SUNDRY NOTICES AND REPORTS ON WELLS

Diamond 8 Fed Com 2H

EOG Resources requests to change the casing program on the approved APD to:

PECOS DISTRICT CONDITIONS OF APPROVAL

Proposed Wellbore

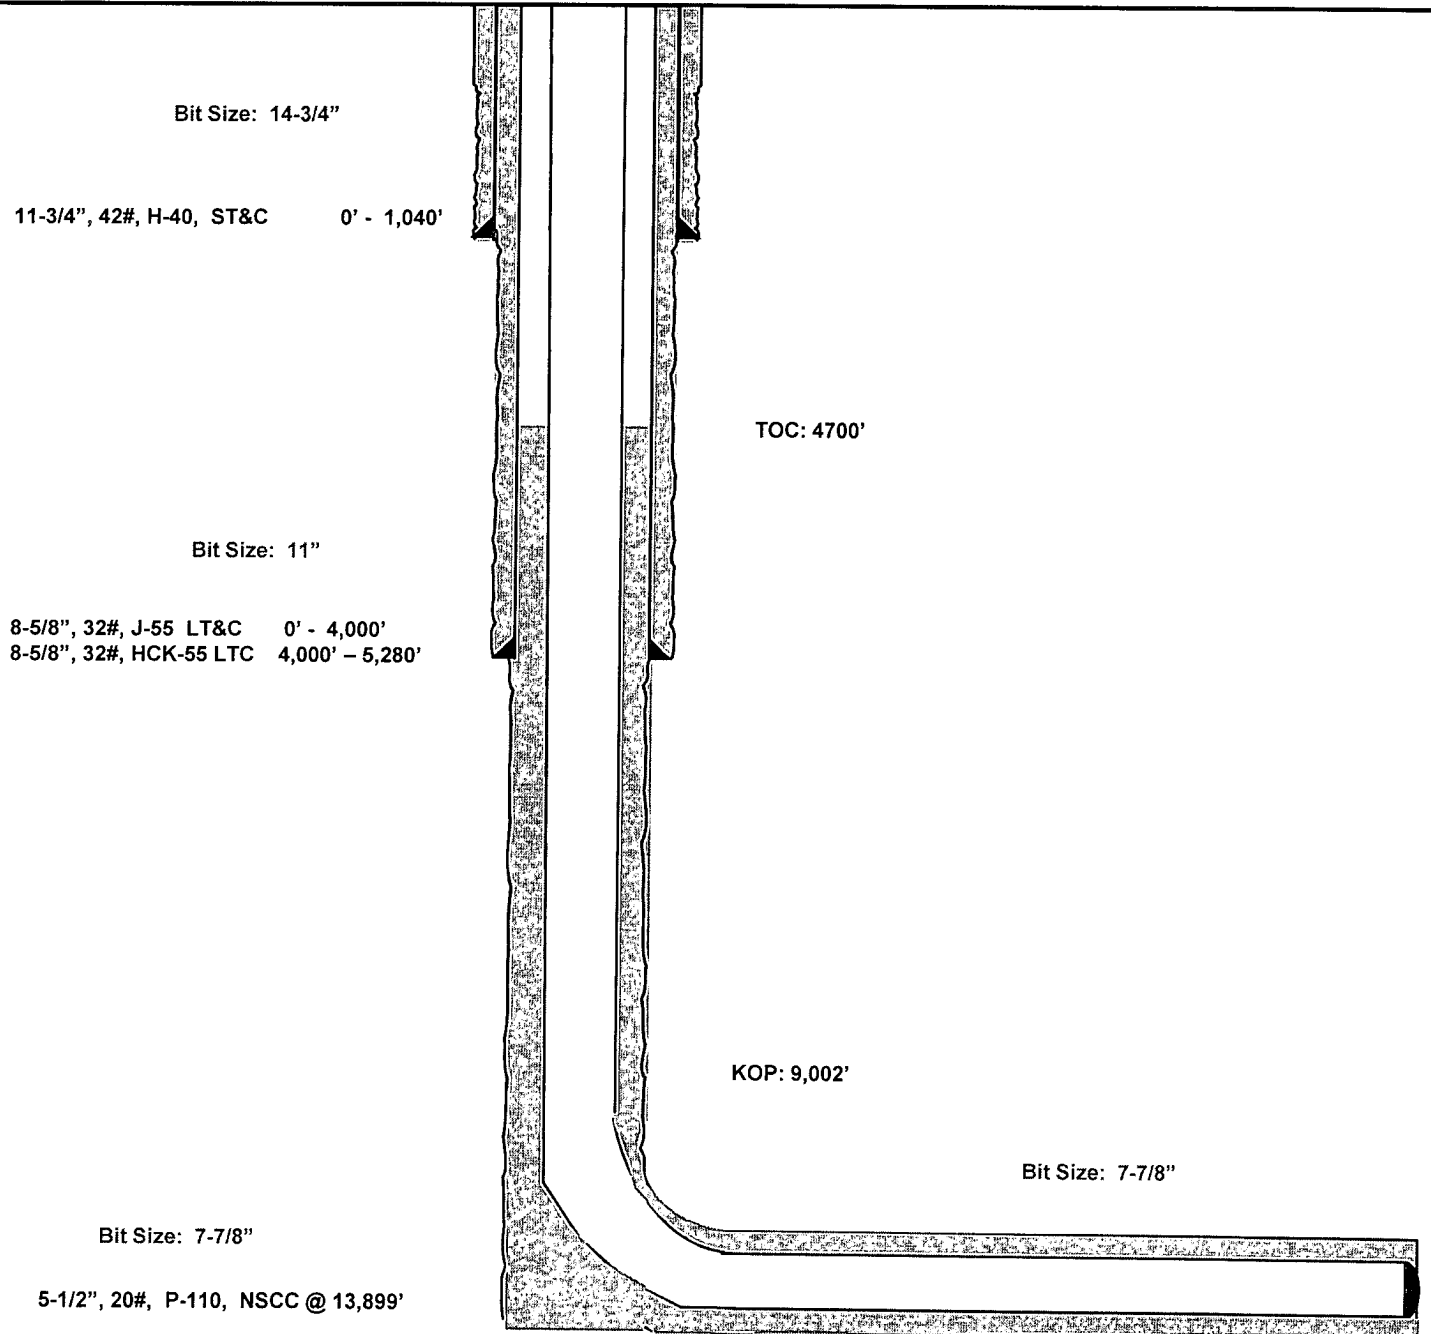
14.75" bit size - 11.75" surface casing

11" bit size - 8.625" intermediate casing

7.875" bit size - 5.5" production casing

Anticipated spud date is 2/4/2011. Detail attached.

1. **The 11-3/4 inch surface casing shall be set at approximately 1040 feet (a minimum of 25 feet into the Rustler Anhydrite and above the salt) and cemented to the surface. Additional cement may be required as excess calculates to 23%.**
 - a. **If cement does not circulate to the surface, the appropriate BLM office shall be notified and a temperature survey utilizing an electronic type temperature survey with surface log readout will be used or a cement bond log shall be run to verify the top of the cement. Temperature survey will be run a minimum of six hours after pumping cement and ideally between 8-10 hours after completing the cement job.**
 - b. **Wait on cement (WOC) time for a primary cement job is to include the lead cement slurry.**

- c. Wait on cement (WOC) time for a remedial job will be a minimum of 4 hours after bringing cement to surface or 500 pounds compressive strength, whichever is greater.
 - d. If cement falls back, remedial cementing will be done prior to drilling out that string.
2. The minimum required fill of cement behind the **8-5/8** inch intermediate casing is:
- ☒ Cement to surface. If cement does not circulate see B.1.a, c-d above. **Casing to be set in the Lamar Limestone.**

3. The minimum required fill of cement behind the **5-1/2** inch production casing is:
- ☒ Cement should tie-back at least **500** feet into previous casing string. Operator shall provide method of verification.
4. If hardband drill pipe is rotated inside casing, returns will be monitored for metal. If metal is found in samples, drill pipe will be pulled and rubber protectors which have a larger diameter than the tool joints of the drill pipe will be installed prior to continuing drilling operations.
